Wisconsin Department of Transportation

**Proposal #34: 1035-04-71, WISC 2018 170
N-S Freeway, Ken&Rac Work Zone Prep
Sth 142 to Cth G
IH 41
Racine County/Kenosha County**

This is Addendum No. 02, which provides for the following:

Addendum No. 02
ID 1035-04-71
Revised Sheet 3
February 9, 2018

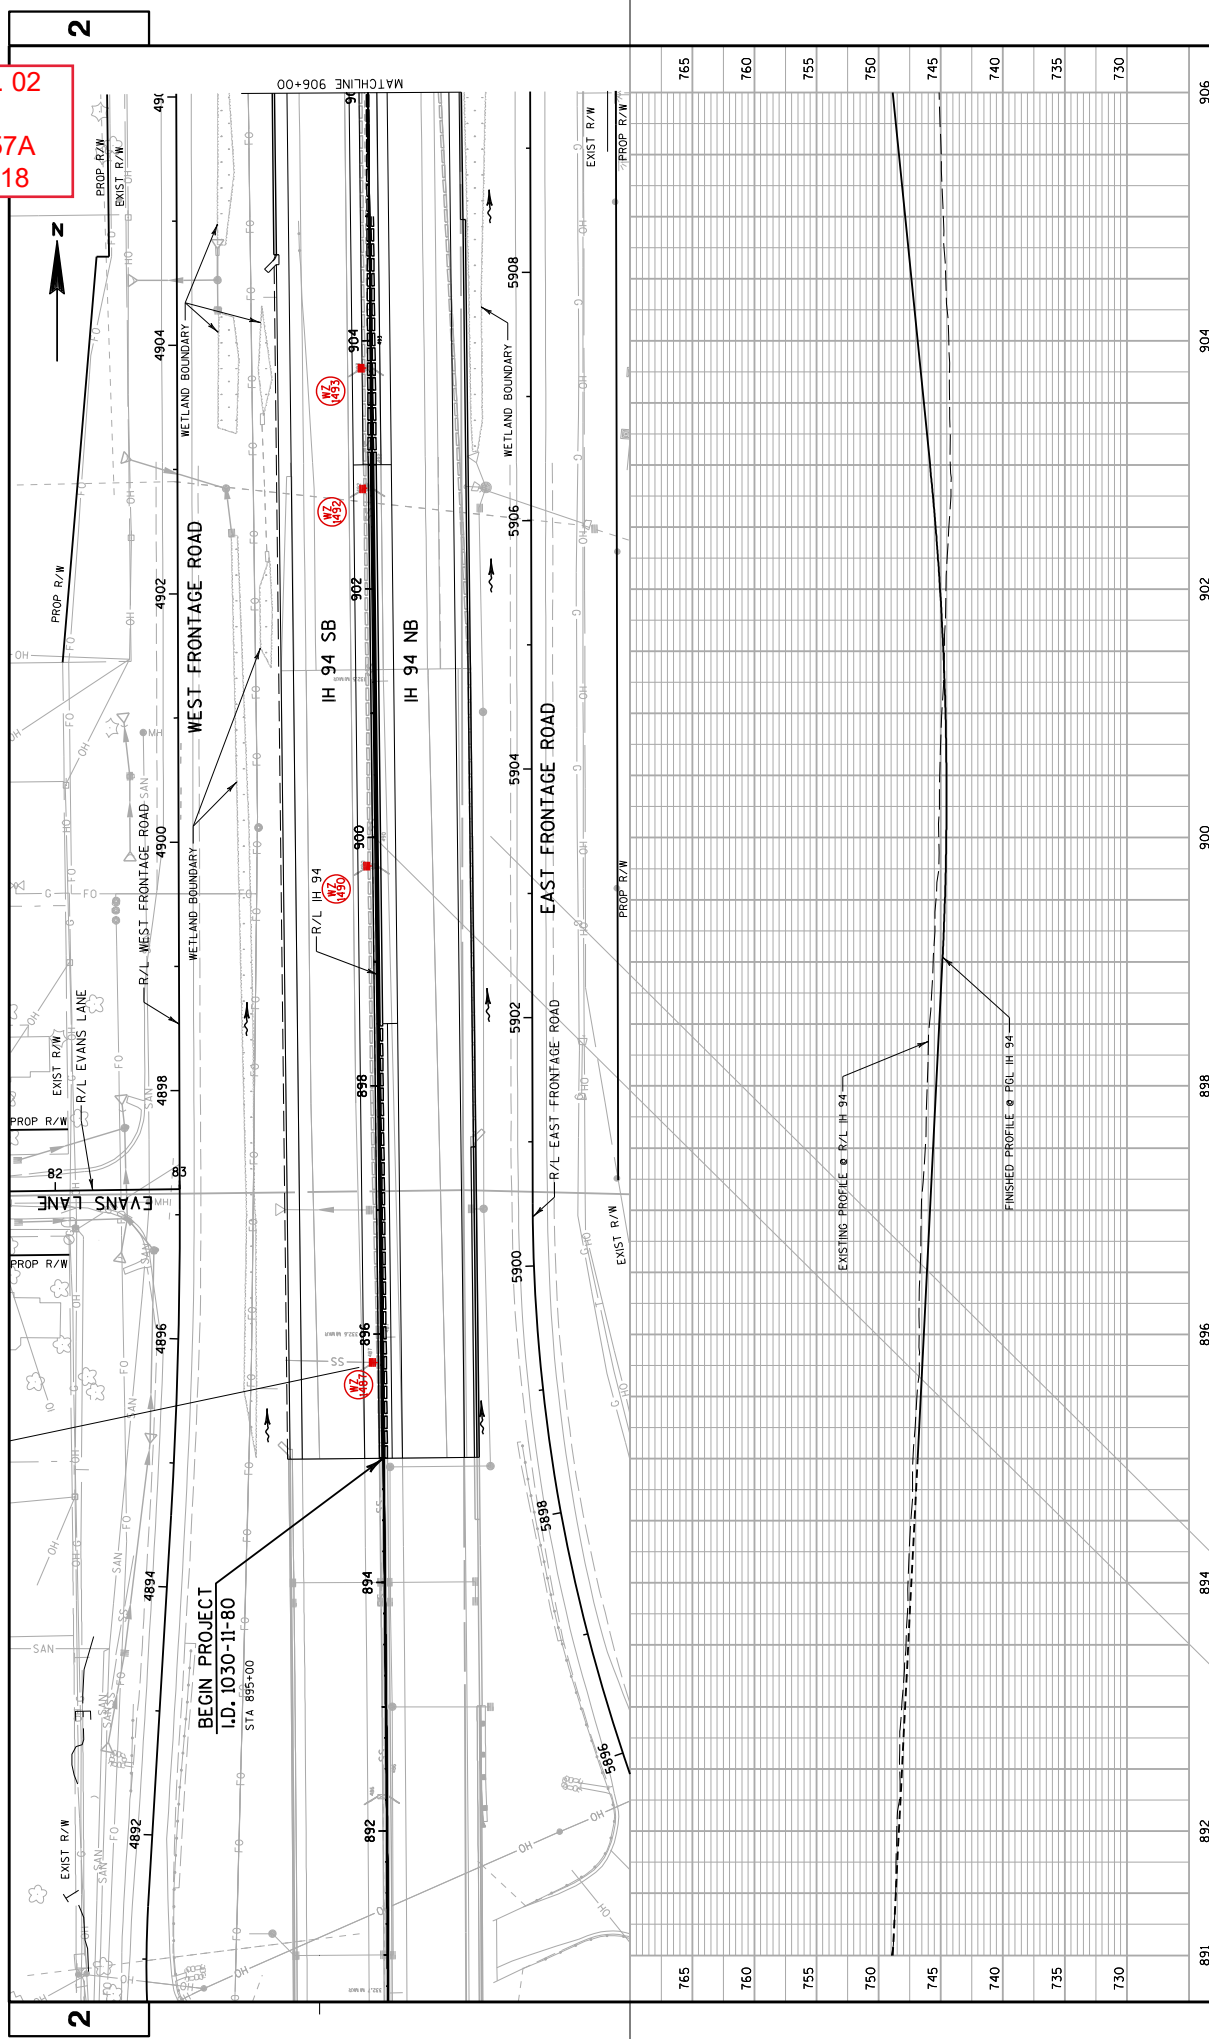
Revised Plan Sheets	
Plan Sheet	Plan Sheet Title (brief description of changes to sheet)
3	General Notes (Added notes)
22	Construction Details (Revised ingress/egress)
58-60, 62	Storm Sewer (Revised drainage due to staging revision)
114, 121A-121F, 151-167, 172	Traffic Control (Added and updated speed limit signs for speed reduction, updated barrier callouts, edited storm sewer notes)
217-219, 223, 225, 226, 229-235, 238-241	Miscellaneous Quantities (Revisions to various repair, drainage, traffic control items)
262-266	Plans (Added inlets)
308	SDD – Pavement Marking (Turn Lanes)

Addendum No. 02
 ID 1035-04-71
 Added Sheet 57A
 February 9, 2018

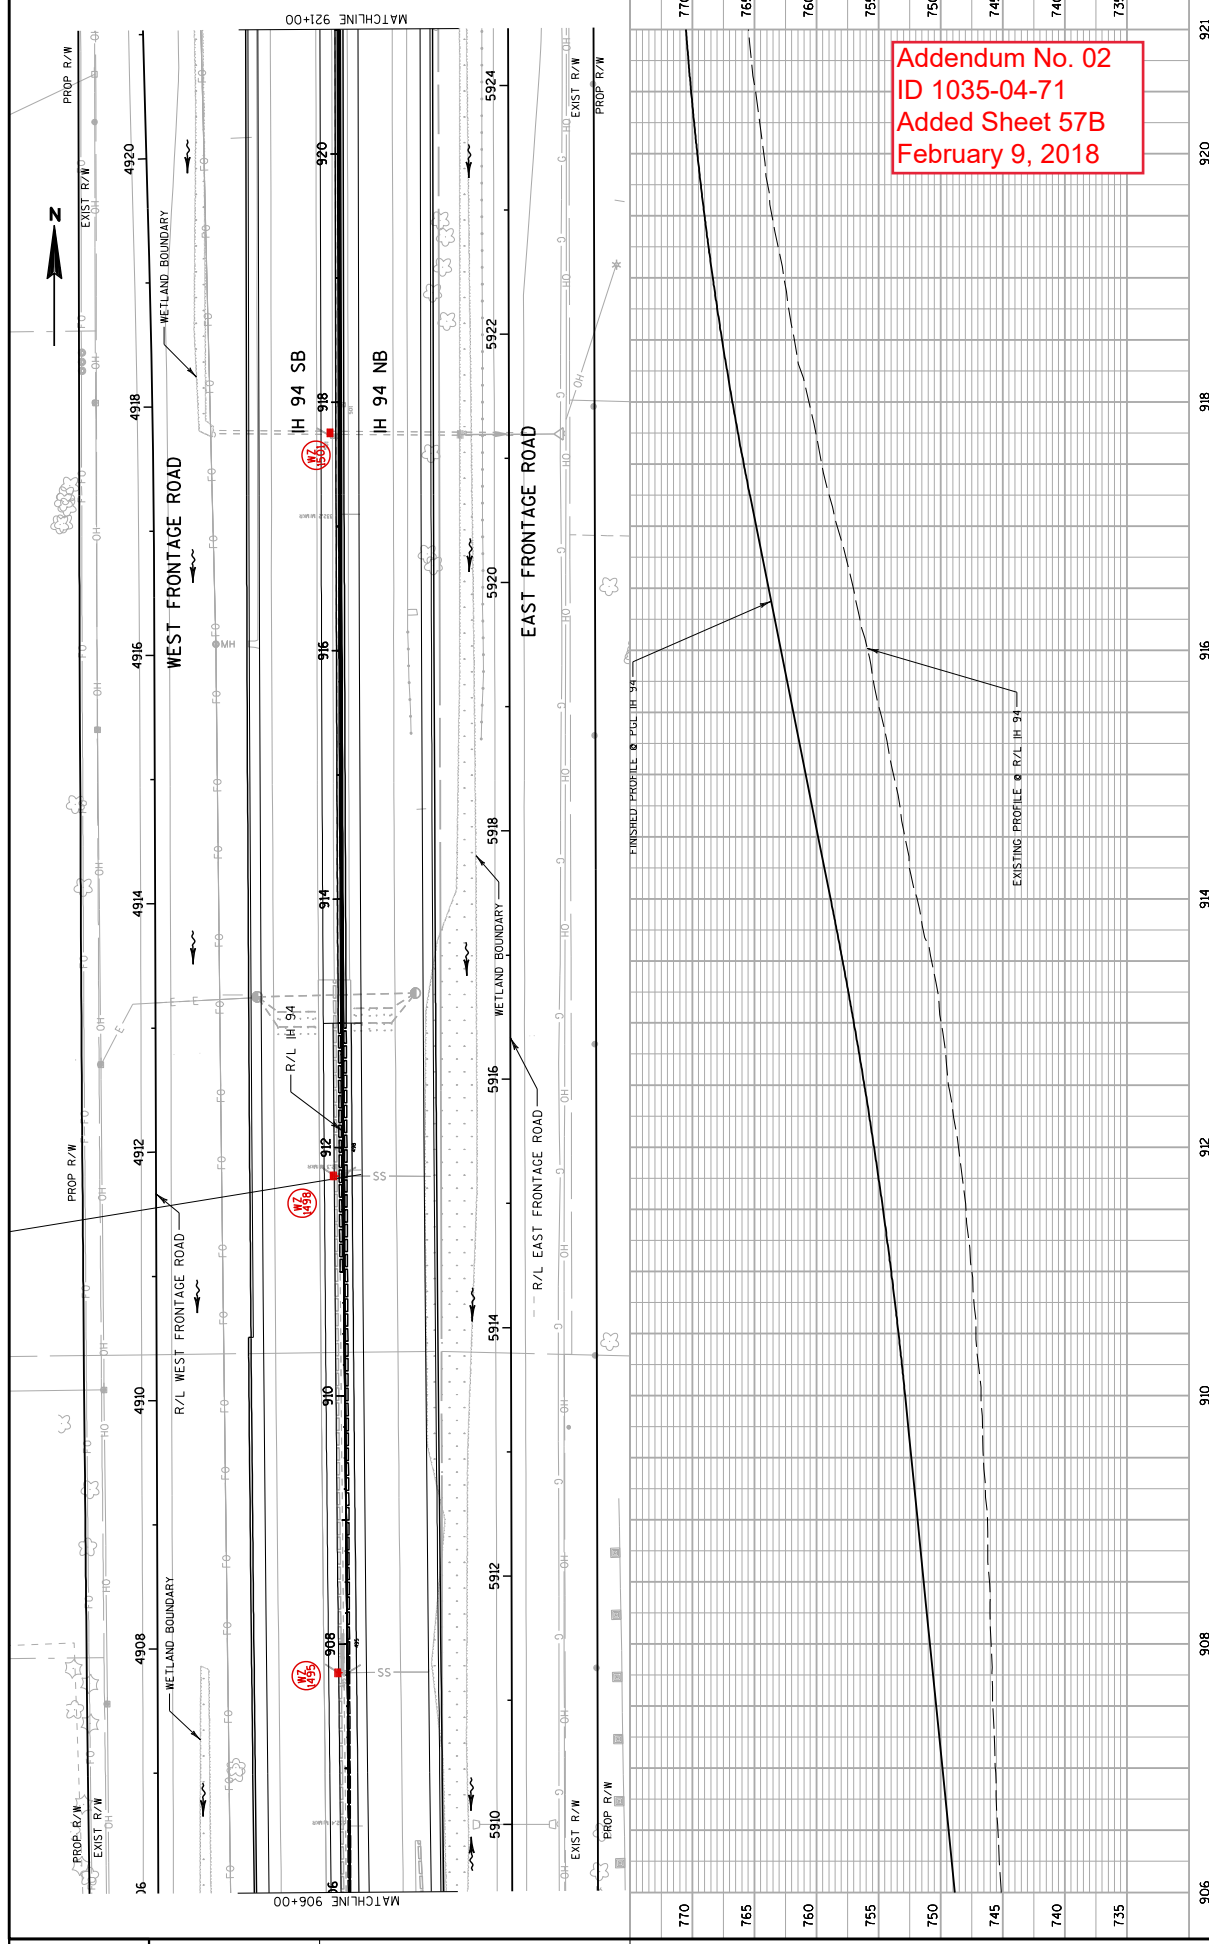
Added Plan Sheets	
Plan Sheet	Plan Sheet Title (brief description of changes to sheet)
57A-57B, 62A-62F	Storm Sewer (added drainage due to staging revision)
64A, 64B	Construction Details (Added Overhead Sign Support)
226A, 230A, 231A, 231B, 241A	Miscellaneous Quantities (Revisions to various repair, drainage, traffic control items)
269A	Plan (added STH 20 SB Exit Ramp work)
285A-C	SDD – Concrete Pavement Repair and Placement
306A	SDD – Pavement Marking Words
306B	SDD – Pavement Marking Symbols
309A	SDD – 36" Diameter Cantilever Overhead Sign Support Base
311A	SDD – Temporary Emergency Pullouts
327A	Standard Sign Plate A4-6 – Attachment of Guide Signs to Supports
327B	Standard Sign Plate A4-7 – Type I Sign Connection to Overhead Sign Support
331A	Standard Sign Plate A5-2 – Aluminum Extrusions for Type I Signs
336A	Standard Sign Plate R3-8P – Standard Sign R3-P & R3-Q
584A to J	Cross Sections (added STH 20 SB Exit Ramp work)

Addendum No. 02
 ID 1035-04-71
 Deleted Sheet 61
 February 9, 2018

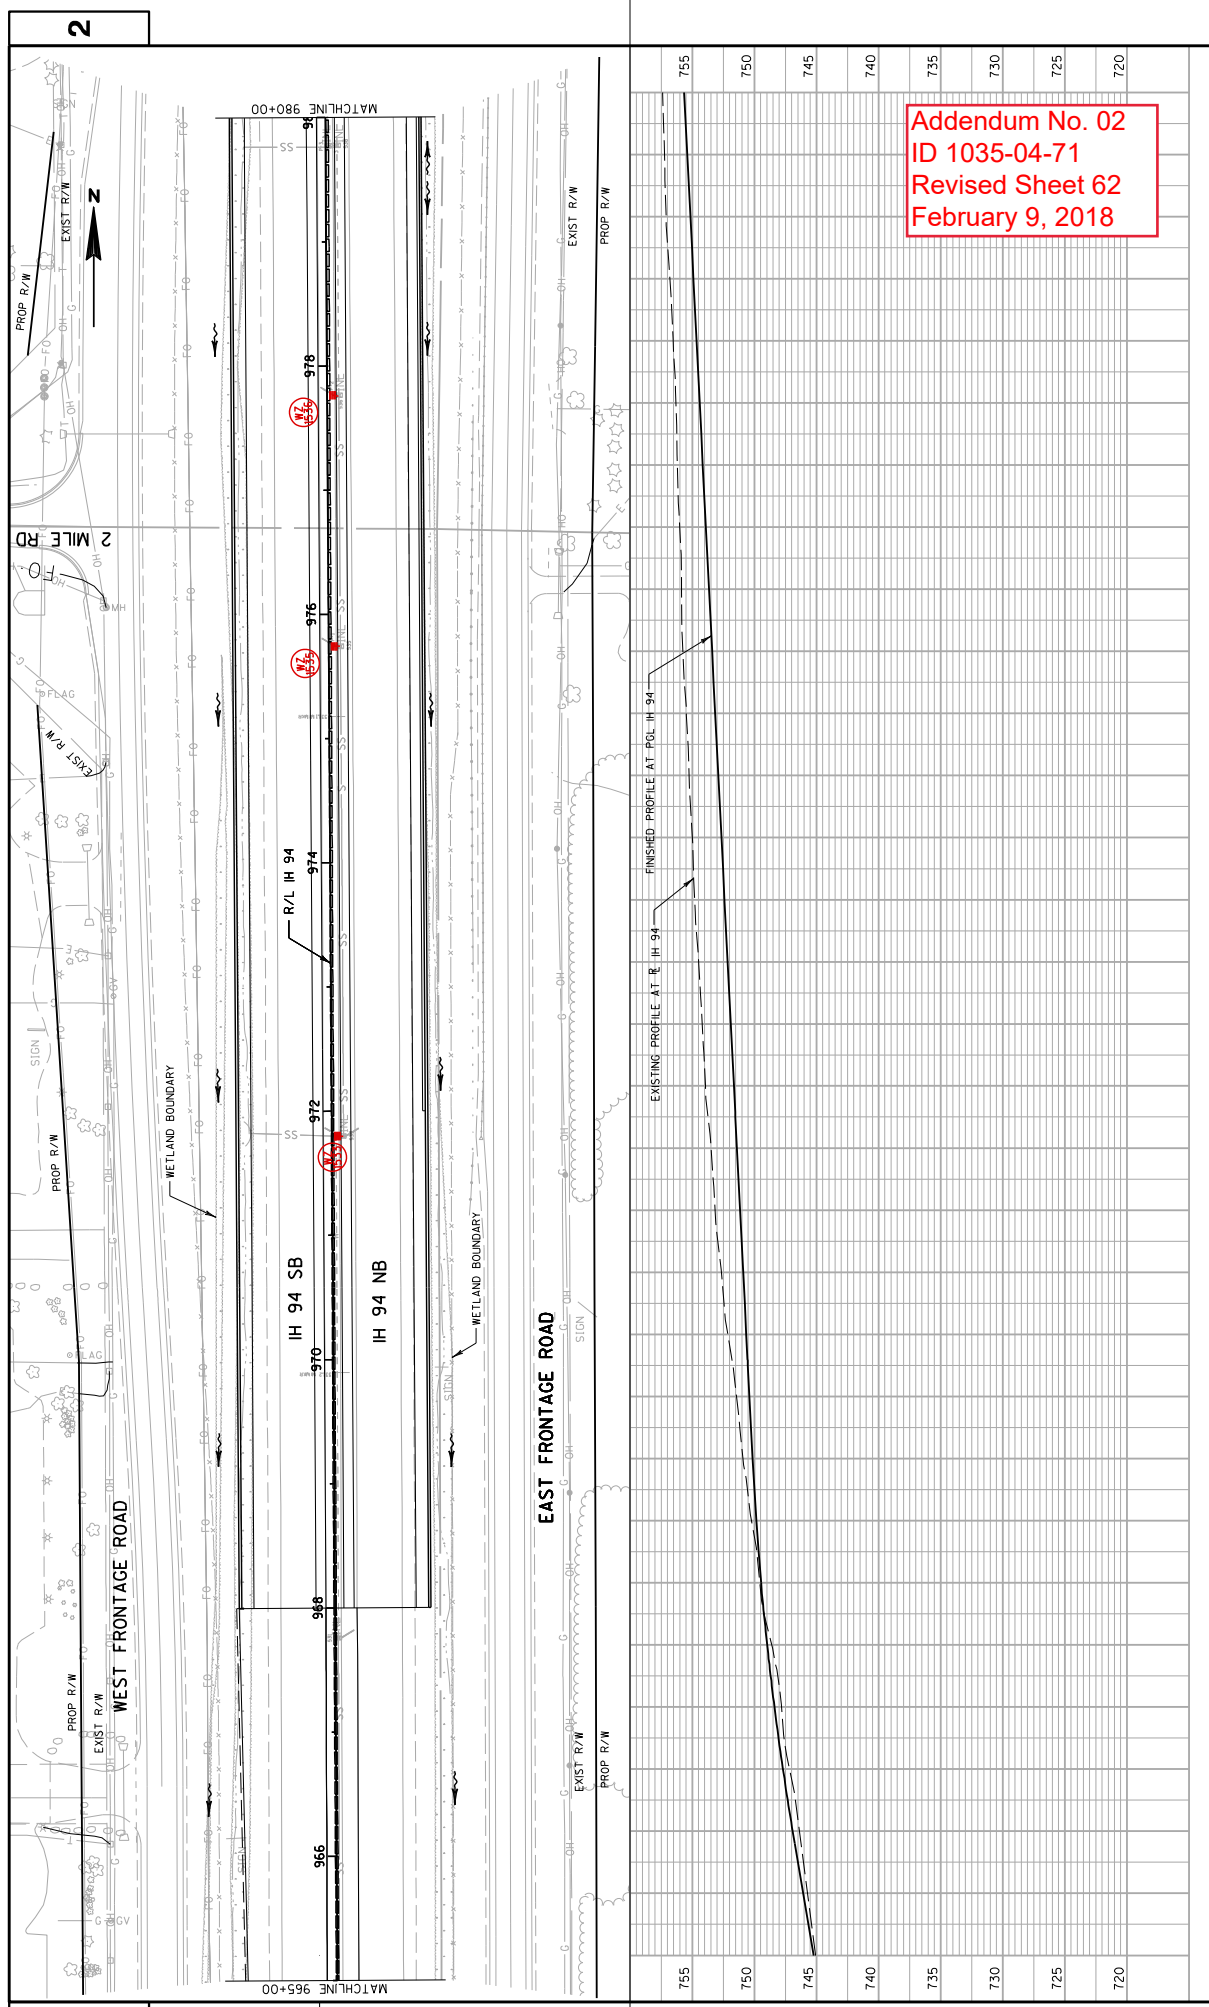
Deleted Plan Sheets	
Plan Sheet	Plan Sheet Title (brief description of changes to sheet)
61	Storm Sewer (deleted due to staging revision)
239A	Miscellaneous Quantities (Revisions to traffic control items)
